**Bloomington Historic Preservation Commission, Zoom Virtual
Meeting, Thursday May 28th, 2020, 5:00 P.M. AGENDA**

COA: 20-20

COA: 20-21

COA: 20-22

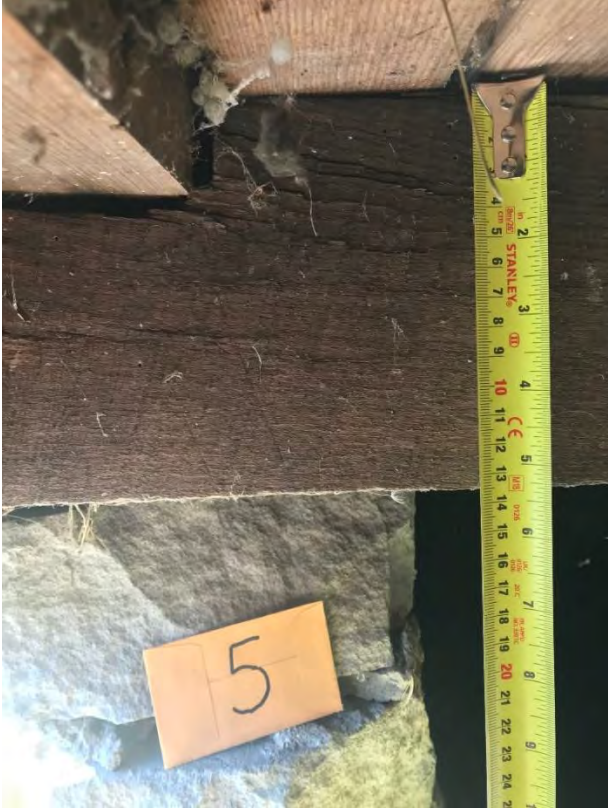
Photo #5: The floor joists are salvage and of various depth and length. They are 5½" deep or less due to the notching at various locations along their length. They are spaced too far apart at 20' on center; they are over-spanned at 14'. Where they reach the outside of the house perimeter, they have no bearing. There is no top plate. They are fastened to the band board by nails only. The band board bears on the top of the foundation by 1" in most places. There is no mechanical connection of the floor framing to the foundation and there is no bridging.

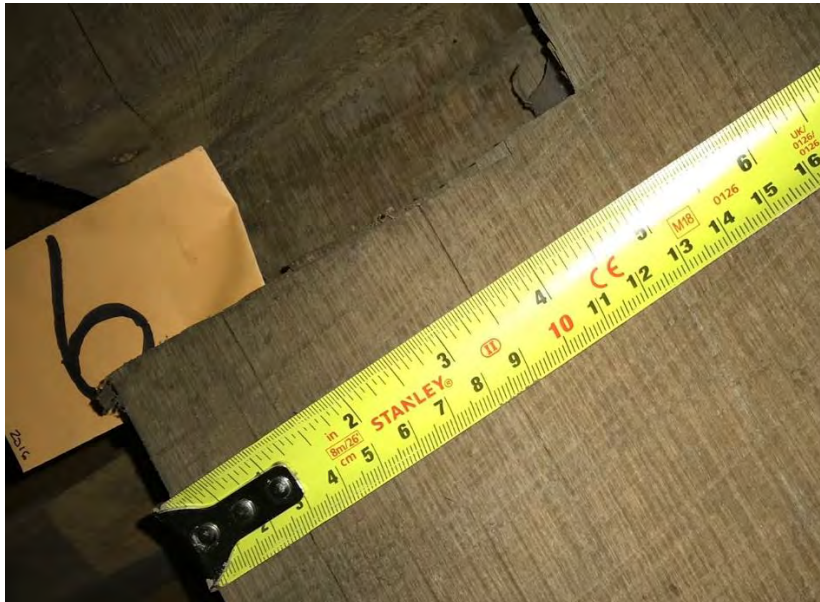
Photo Group 6: The floor box 28' x 28' +/- . The center floor beam, which is 8" wide and 6" deep, runs east to west. The center floor beam is 8" wide and 6" deep, running East to West and the floor joists rest on top of it. It is a salvage beam with various notches and cut out areas from a previous use. It is inadequately supported by metal post of limestone block without any proper footing. The floor framing is wildly underbuilt. Currently the floors could not support any heavy furniture, such my piano and breakfront, which I plan to move there.

Photo Group 7: Framing is 2 x 6, 24" on center over-spanned at 21.' They are twisting, bowing, undulating and caving in. There is skip sheathing, originally with wood shingles but now covered with asphalt. Many parts of the roof framing are salvage material.

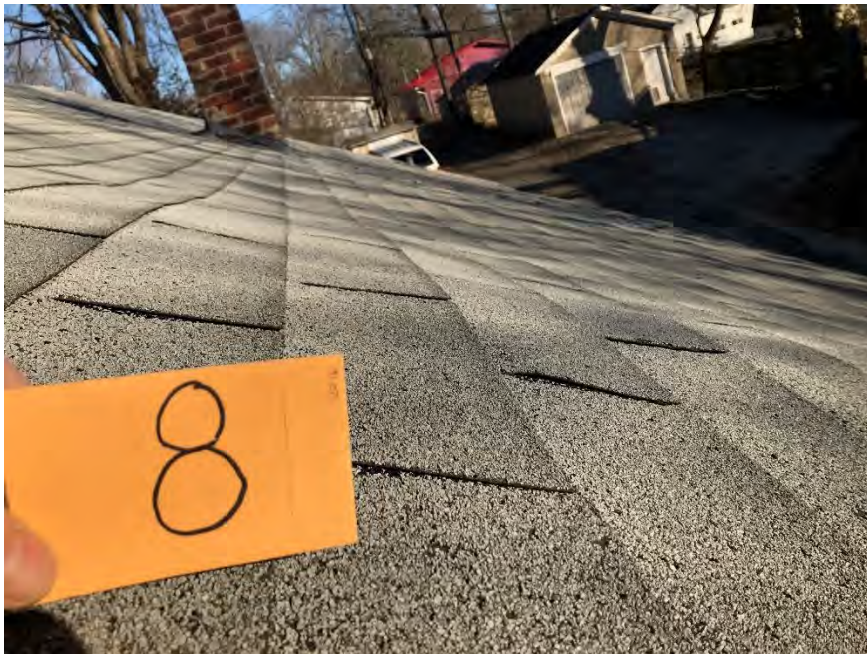
Photo Group 8: There are no ridge, boards, no collar ties and the rafter are deflected and sagging. Rake boards and rafter tails are sagging. The roof plane dips and undulates because it was underbuilt.

Problem Area

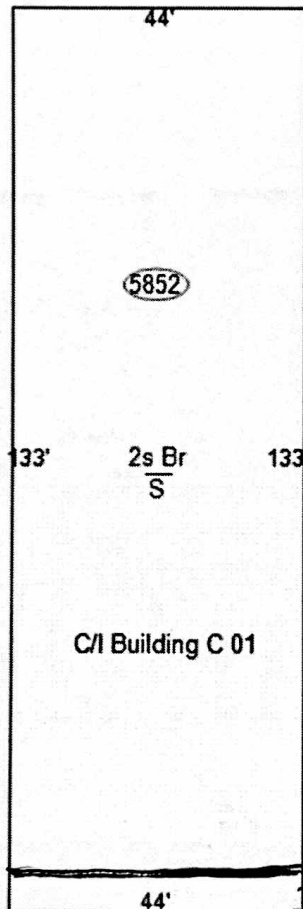
Need to repair the roof. There is an area on the south side of the structure that runs into area/scupper that leaks into the building in several spots. We are asking to fill in the scupper and leveling out the lower level to run into a gutter system. This will not be visible from the street except for the gutter.

Request: Install gutter along cornice line of the building. Similar to what has been done to the building directly to the west. This gutter will feed into existing downspout and eliminate the need for a roof trough which has been attracting trash and is leaking.

1. Running a K-style gutter along the facade, accented to match the building color scheme, would serve to sharpen and enhance the cornice line creating a visually appealing feature.
